**SUBJECT: Campaign 084 - 2007/2008 Santa Fe - Gross Axle Weight Rating (GAWR)  
Correction Label Installation**

Group	CAMPAIGN
Number	08-01-007
Date	JUNE, 2008
Model	2007-2008 SANTA FE

Subject  
**GROSS AXLE WEIGHT RATING CORRECTION LABEL  
 INSTALLATION (CAMPAIGN 084)**

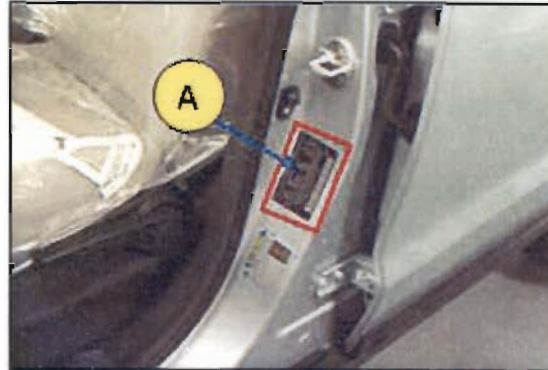
On some Santa Fe (CM) vehicles, the Gross Axle Weight Rating (GAWR) information on the Certification Label may be incorrect. This bulletin describes the procedure to apply the GAWR correction label.

PART NAME	FIGURE
GAWR Correction Label P/N 86463-0W00A	<p><b>ATTENTION</b>          THE GAWR INFORMATION ON THE CERTIFICATION LABEL IS INCORRECT. THE CORRECT GAWR INFORMATION IS LOCATED AT THE BOTTOM OF THIS LABEL.</p> <p>GAWR          FRONT <b>2910 lbs</b>          REAR <b>3131 lbs</b></p>

1. Locate the black Certification Label (A) on the driver's side center pillar as shown.

2. Clean the painted area (B) above the black Certification Label using a rag dampened with rubbing alcohol. Wipe the surface dry with a paper towel.

3. Carefully peel the new GAWR Correction Label from its backing beginning at the center, pulling it downward at an angle towards the other side.

4. Carefully apply the new GAWR Correction Label onto the driver's side center pillar in the painted space above the black Certification Label.
